MONOLITHIC GLASS PERFORMANCE DATA

WEBSTER UNIVERSITY ISB
PROJECT NAME

RE: Stair 1 Glass For Handrail Product Data

RE: Glass handrail Samples

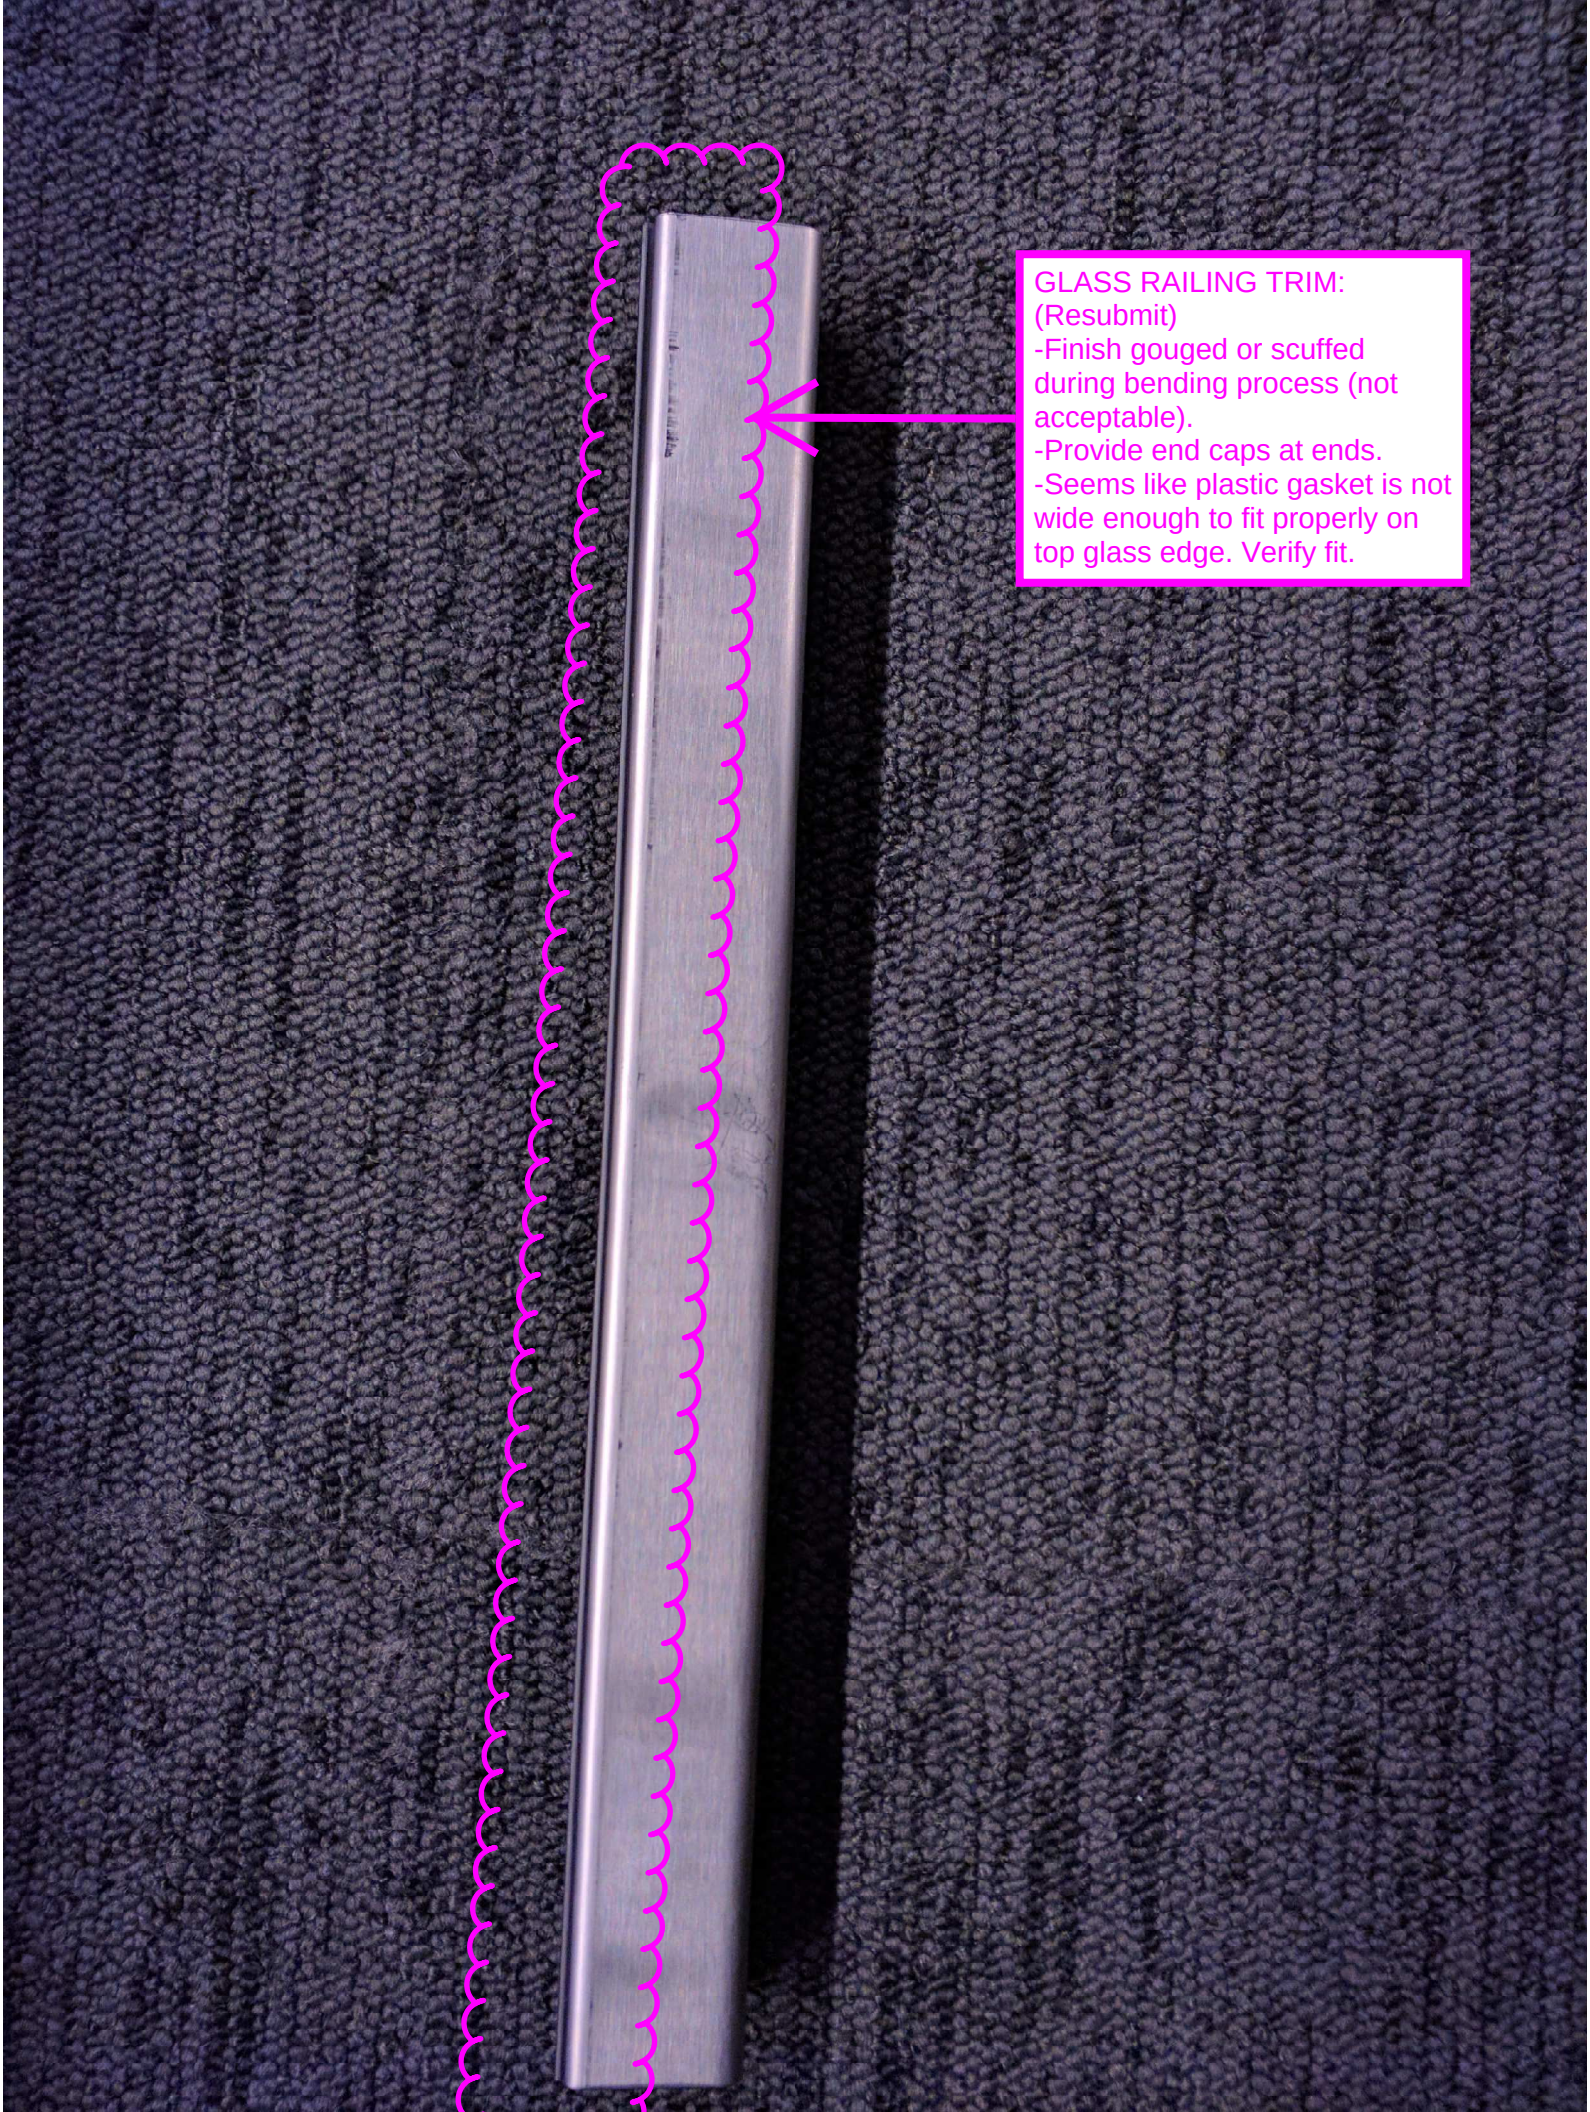
GLASS RAILING TRIM:
(Resubmit)
-Finish gouged or scuffed during bending process (not acceptable).
-Provide end caps at ends.
-Seems like plastic gasket is not wide enough to fit properly on top glass edge. Verify fit.

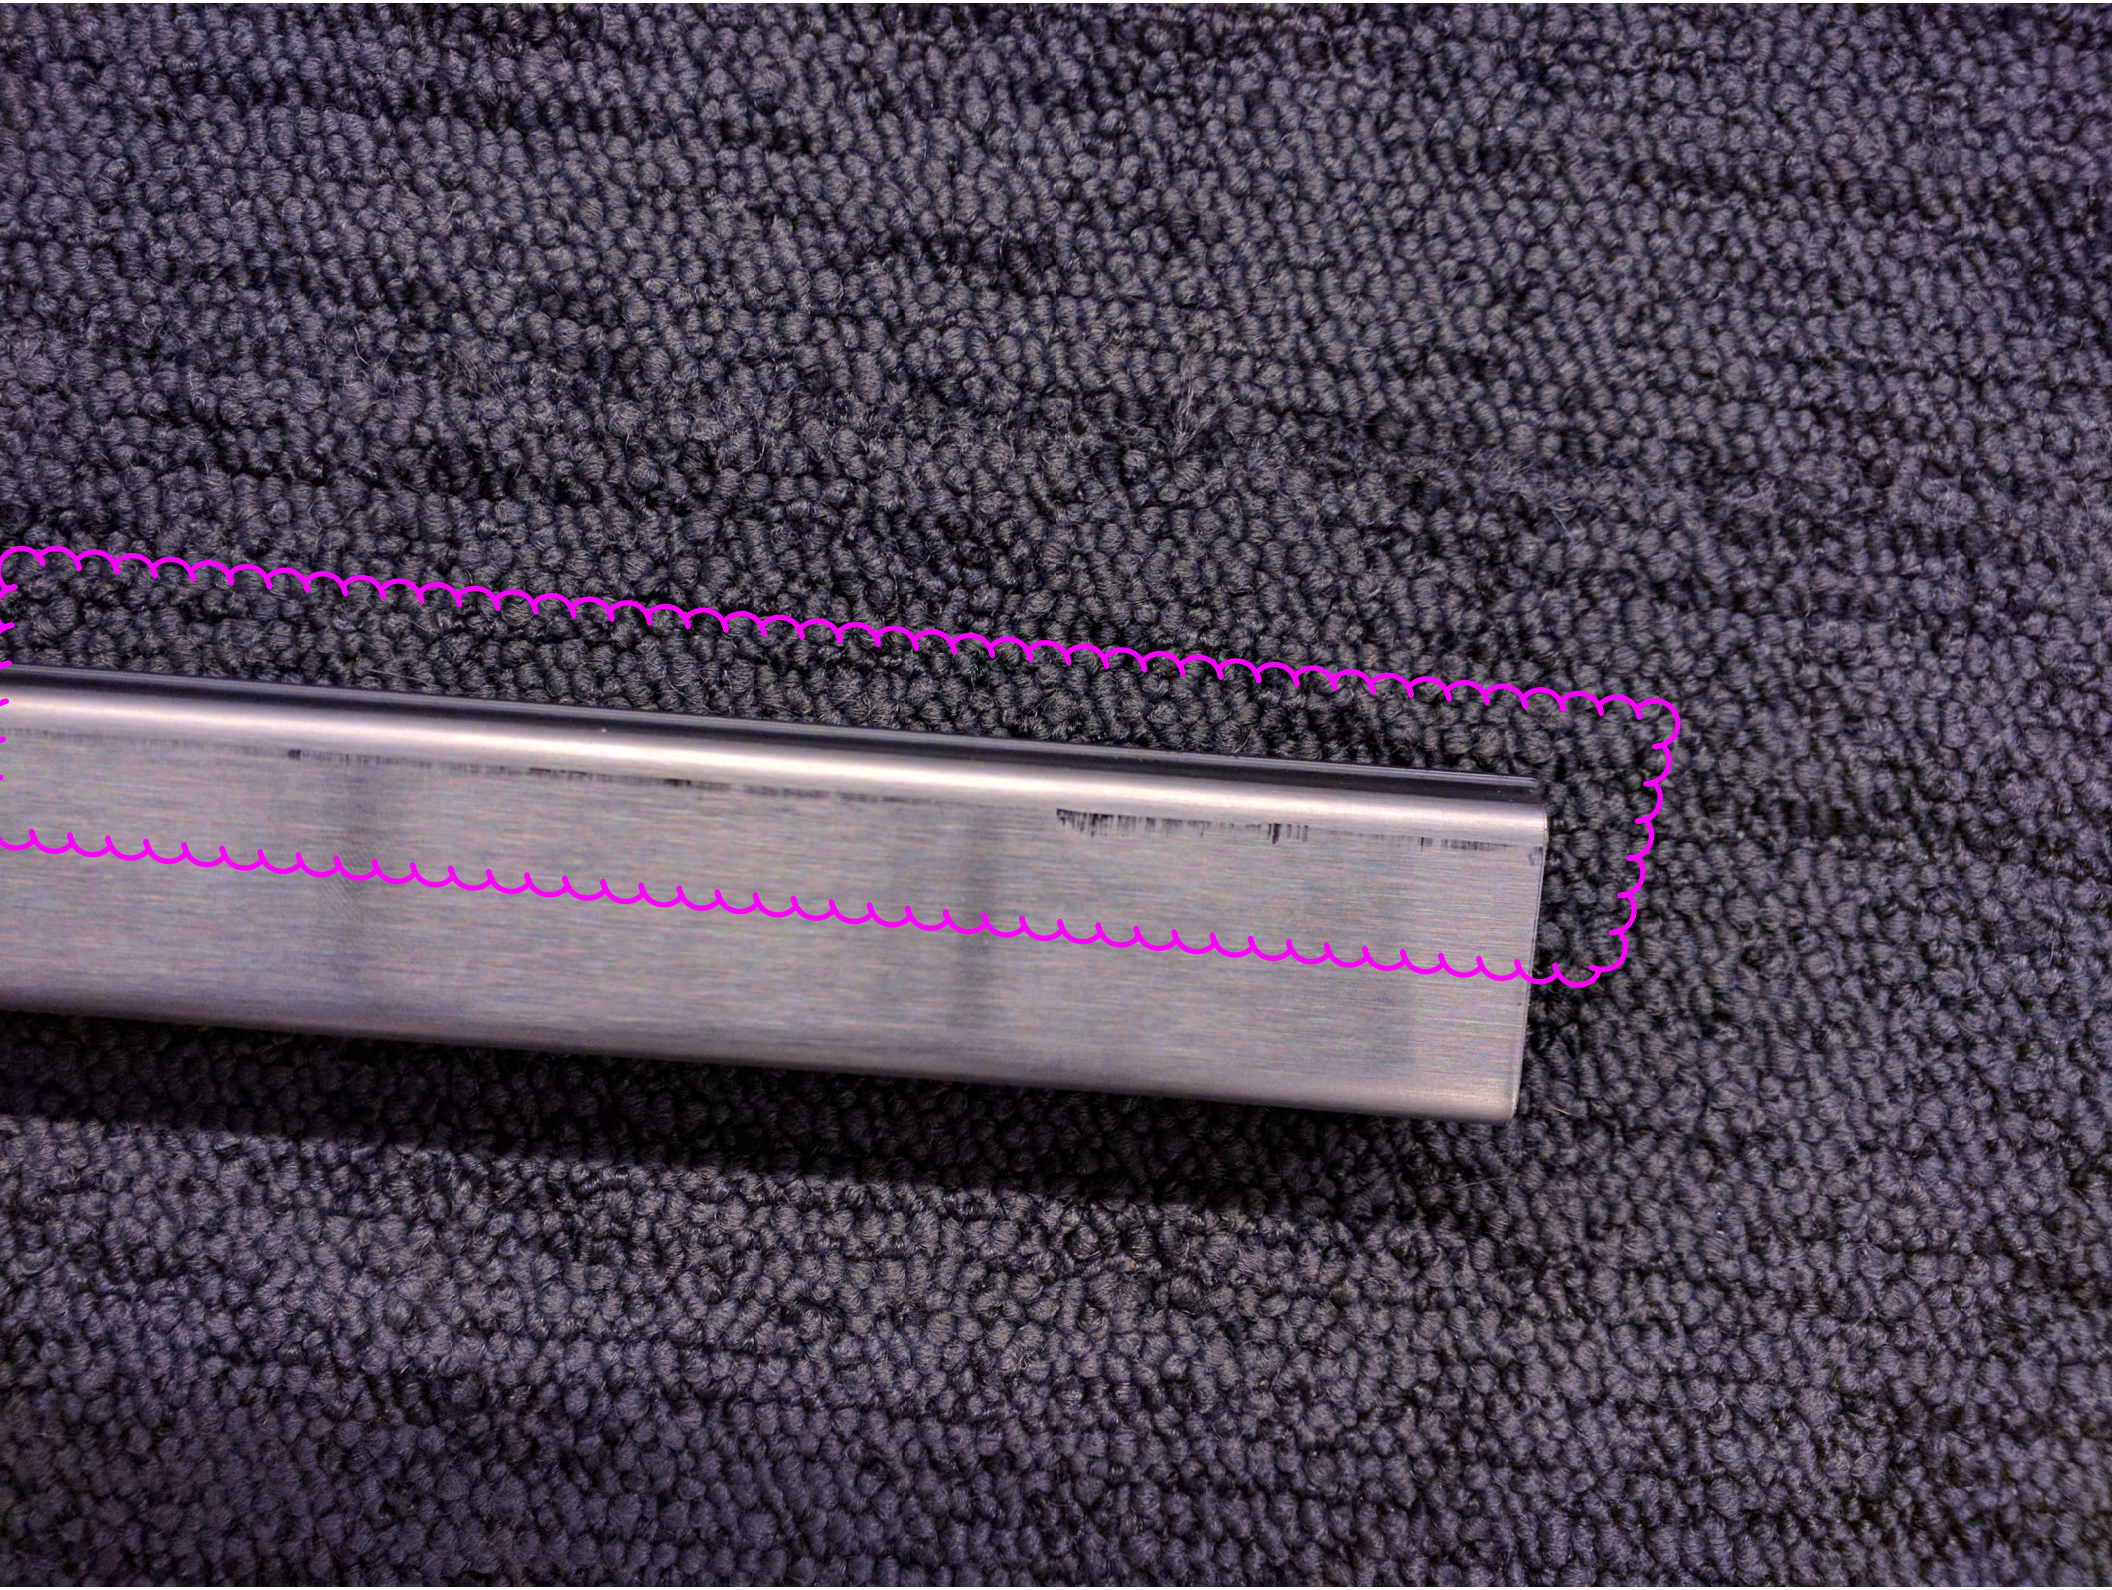
GLASS MOUNT BRACKET:
(MCN)
-Grind weld smooth.
-No discoloration due to
welding burn should be visible.
Polish to match finish.
